Floor Plan Alterations

Level 05 Plan: Consented

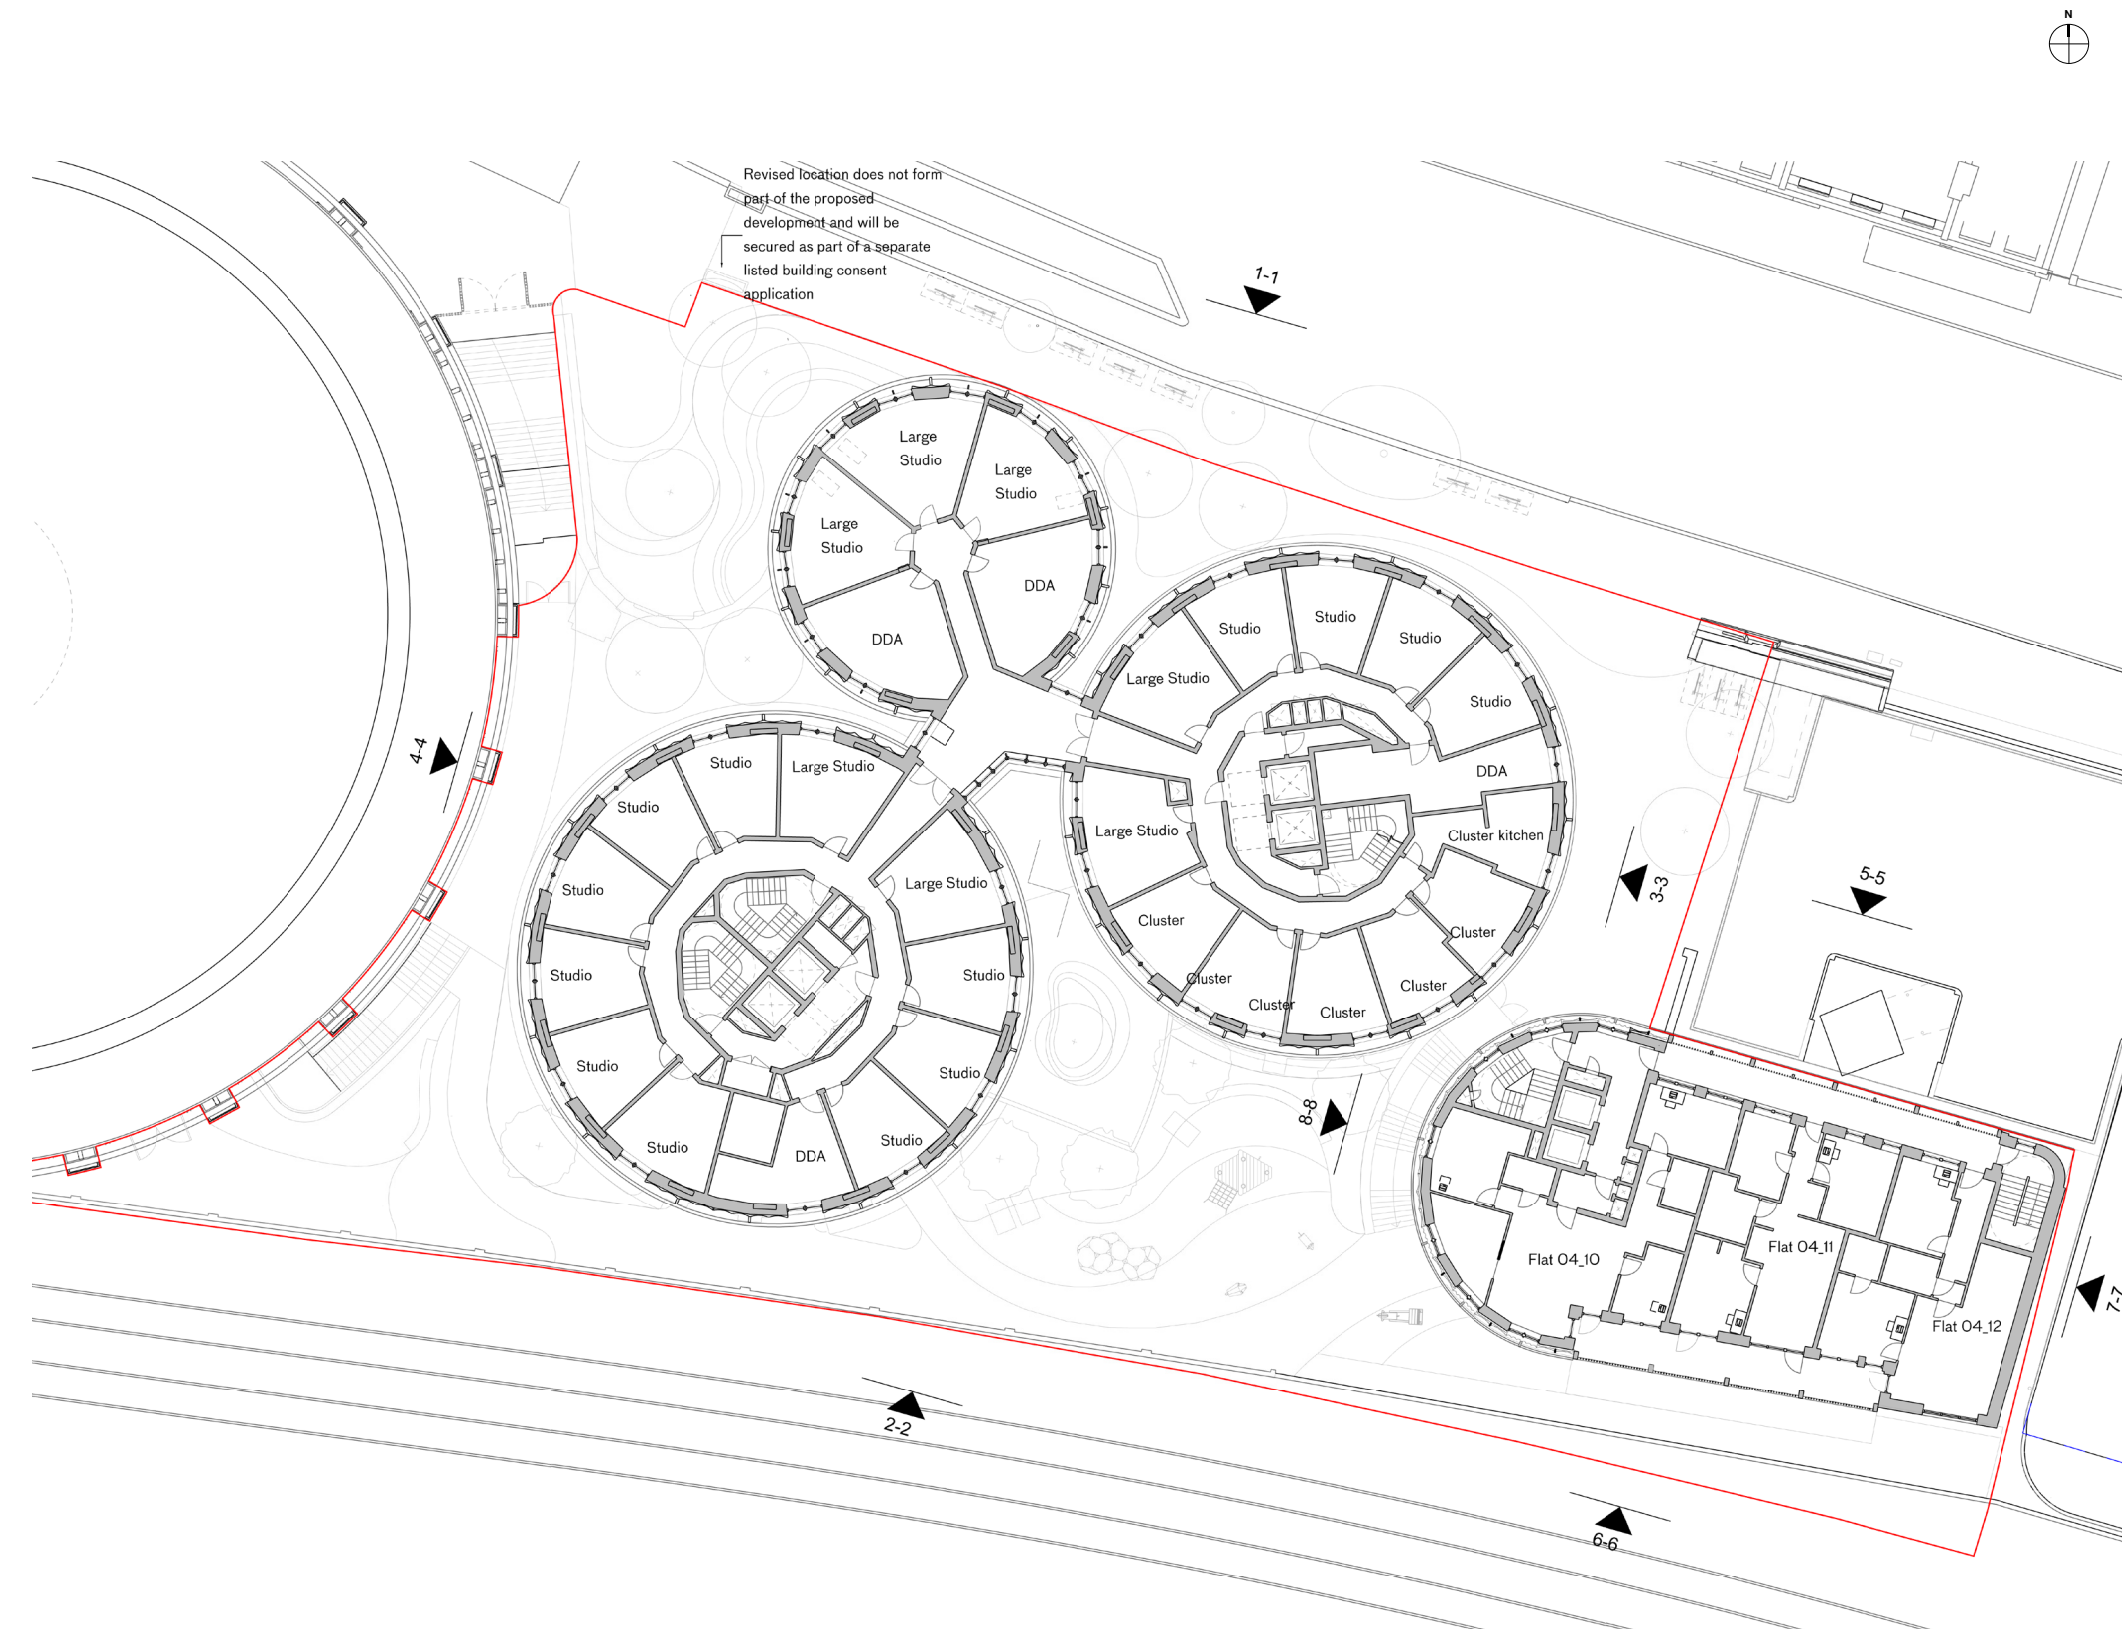
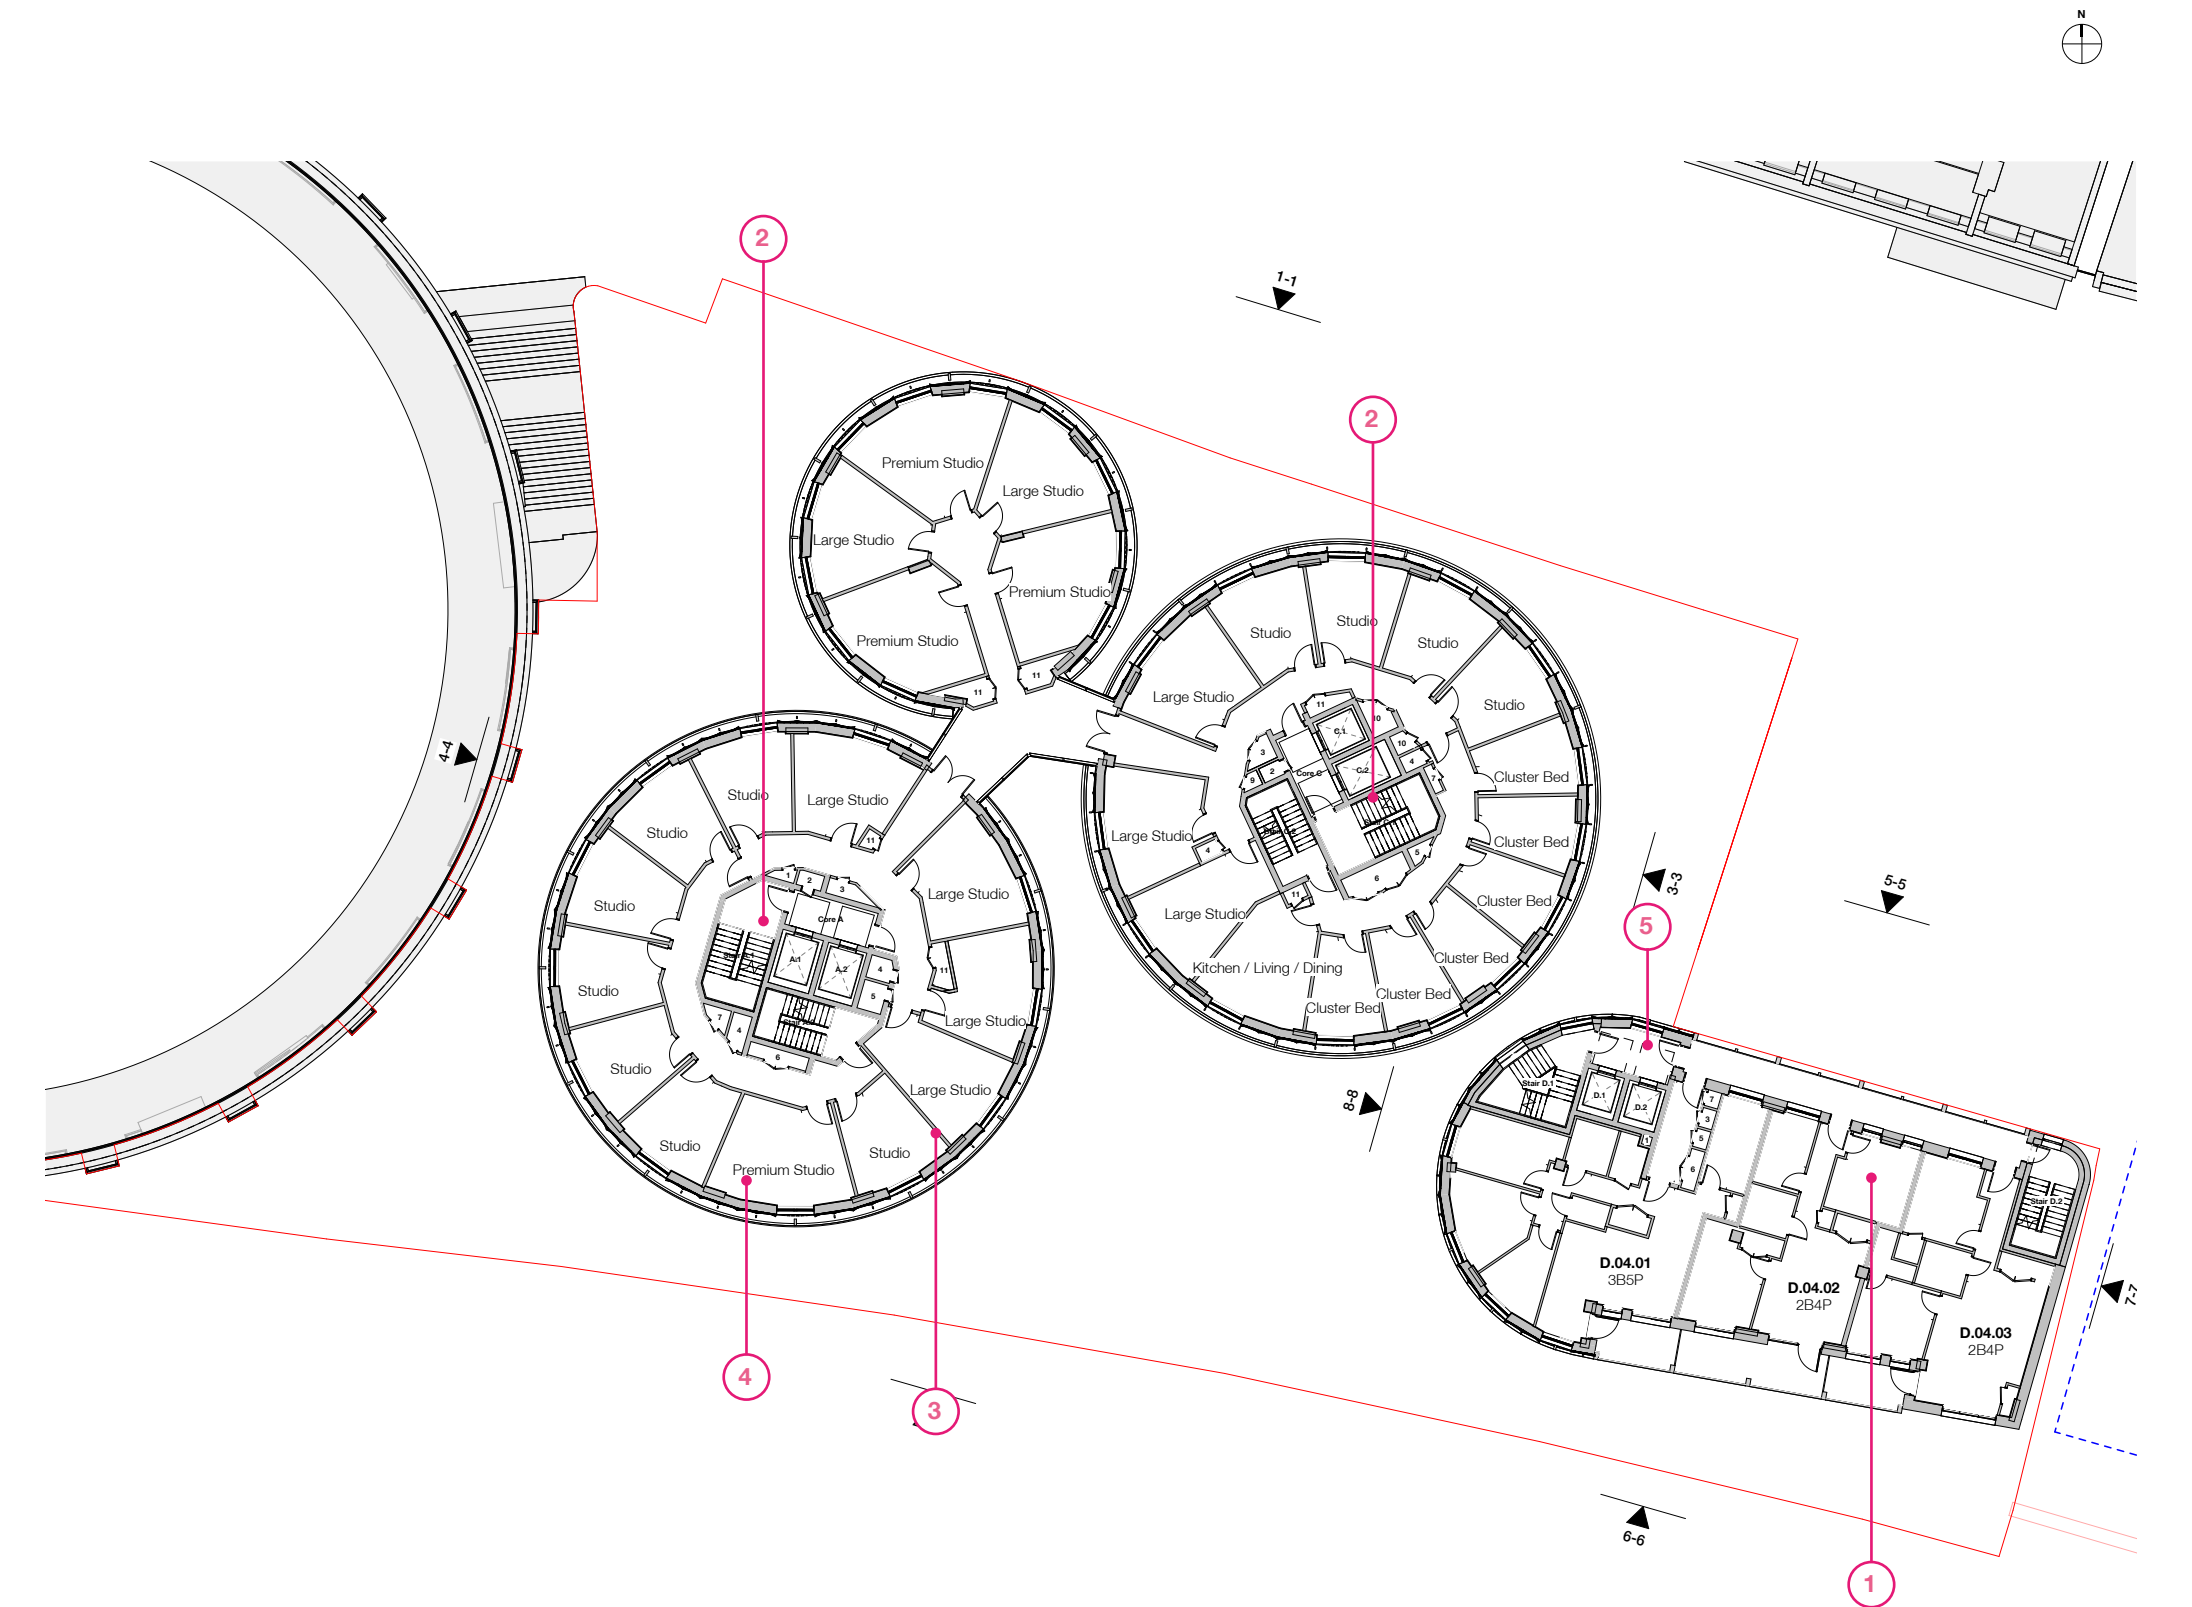
- 1 Flat layouts amended to suit revised core and to meet building regulations
- 2 Core re arranged for fire safety and approved document compliance
- 3 Amendments to studio layouts to suit revised fire strategy. Amendments to studios do not affect sizes.
- 4 Accessible studio numbers reduced to 10% (26 numbers)
- 5 AH lobby layout amended to improve circulation

Level 06 Plan: Consented

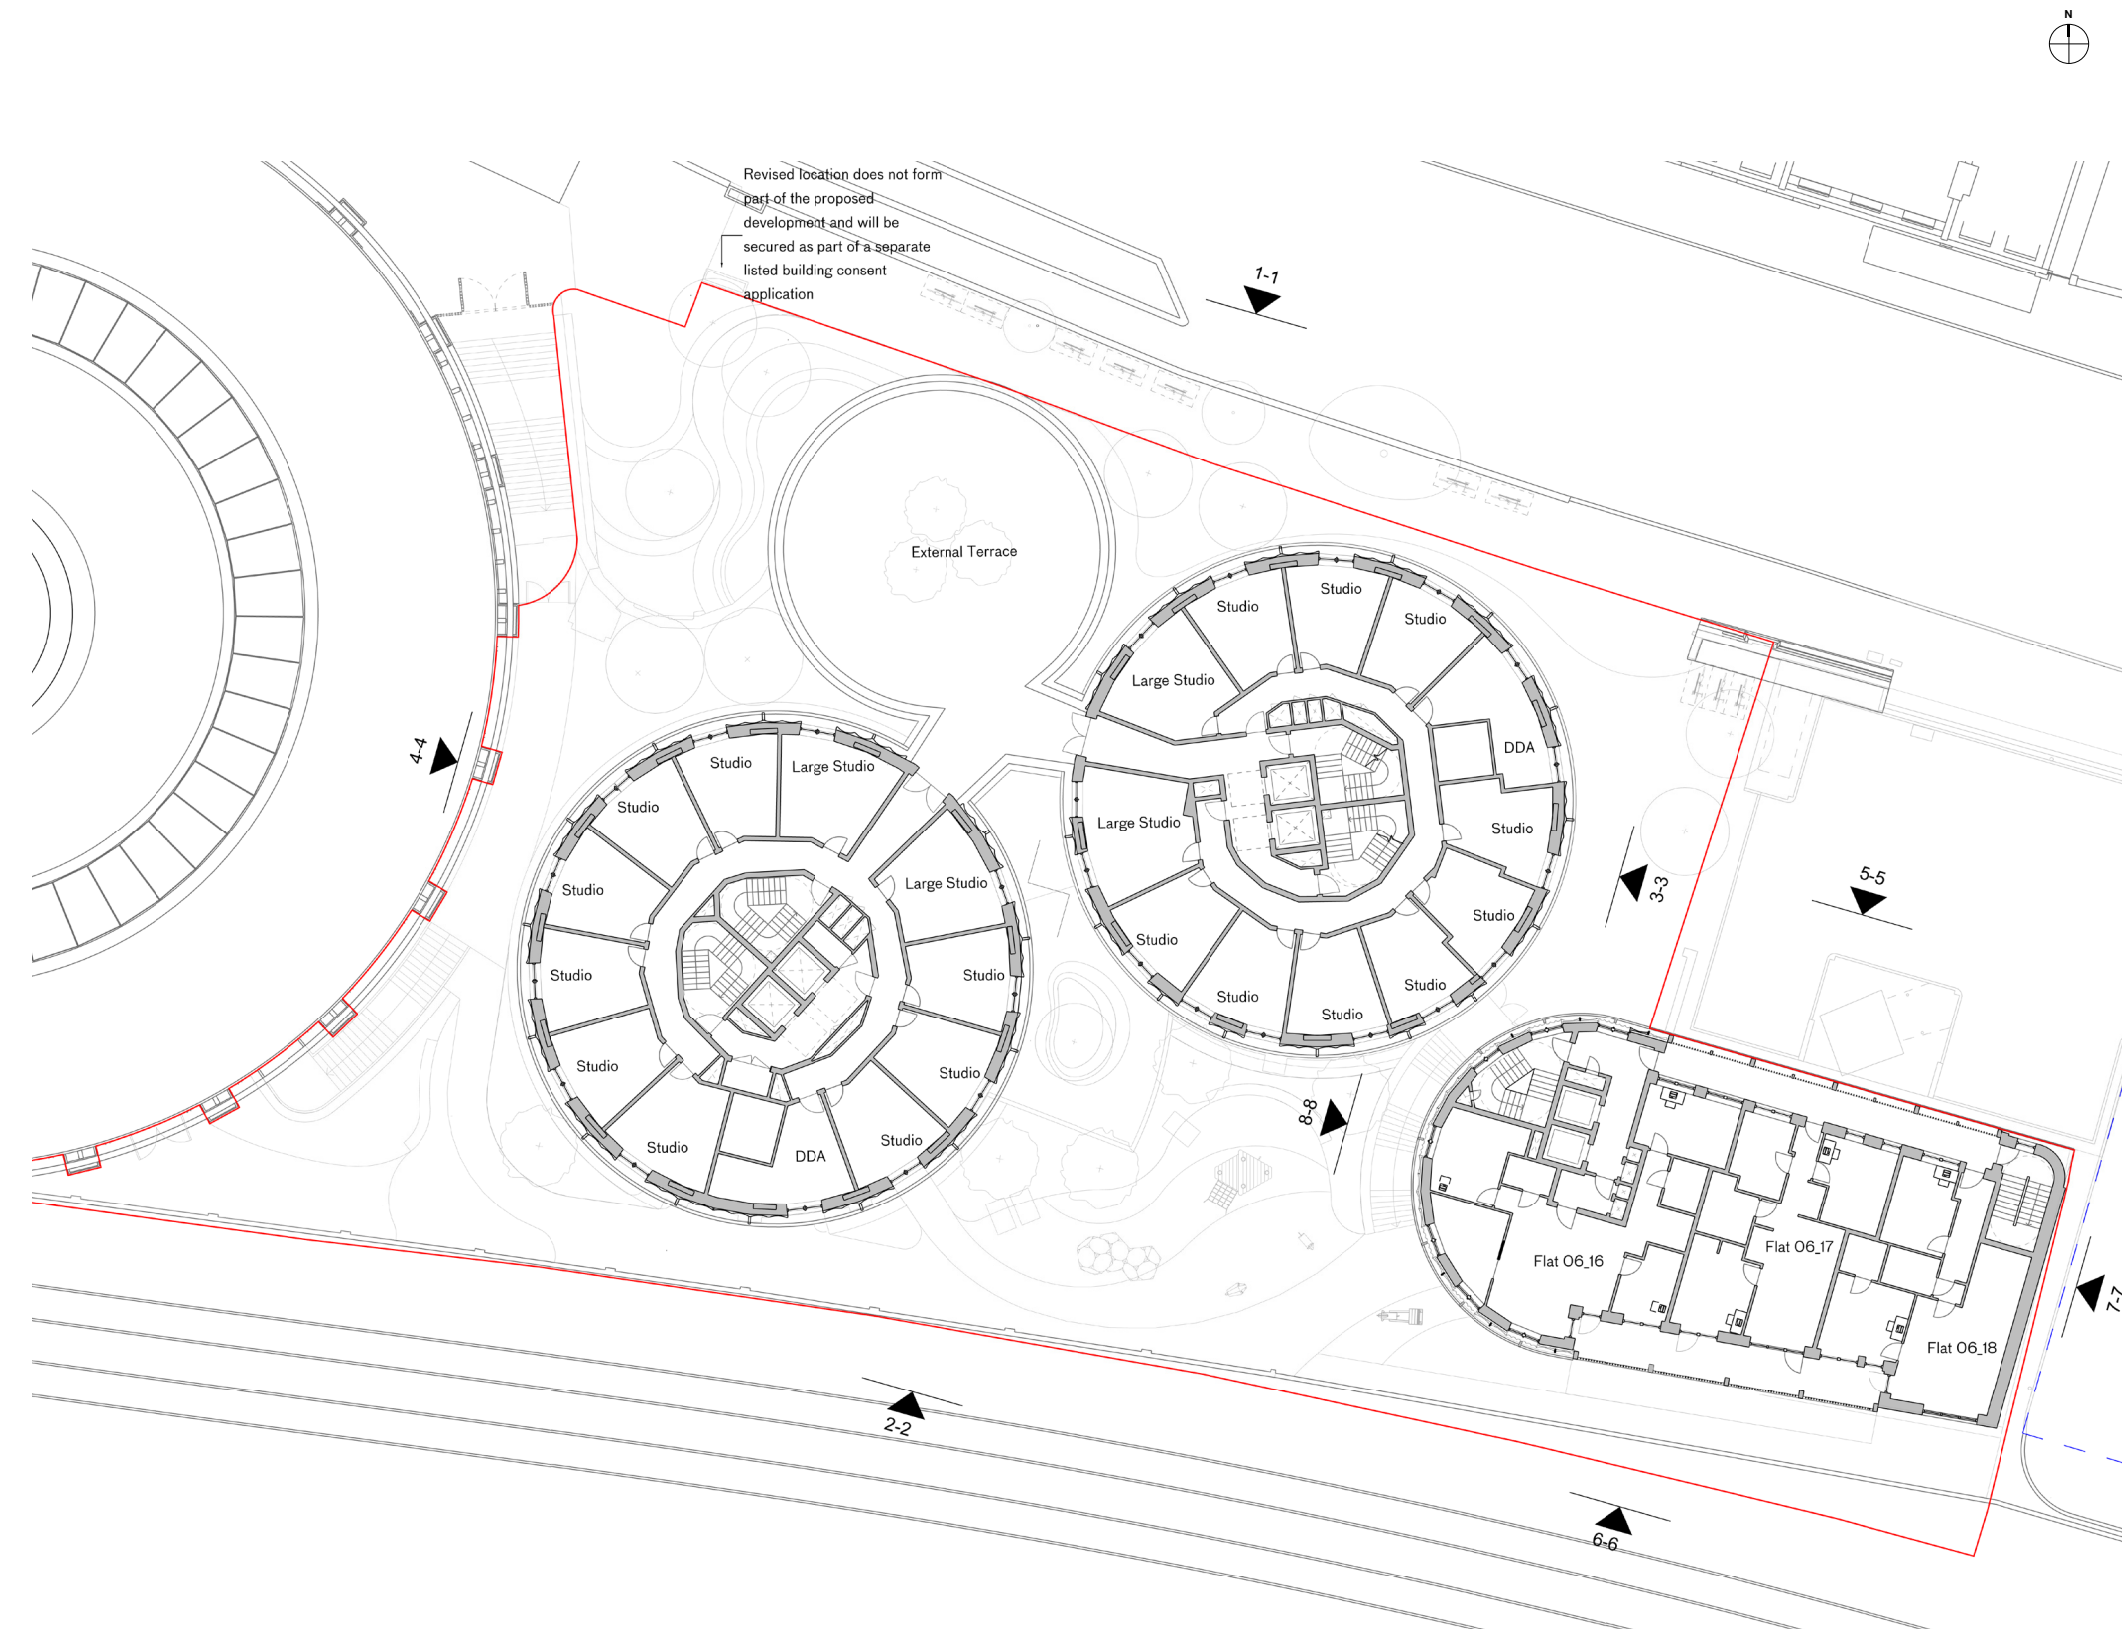
- 1 Flat layouts amended to suit revised core and to meet building regulations
- 2 Core re arranged for fire safety and approved document compliance
- 3 Amendments to studio layouts to suit revised fire strategy. Amendments to studios do not affect sizes.
- 4 Accessible studio numbers reduced to 10% (26 numbers)
- 5 AH lobby layout amended to improve circulation
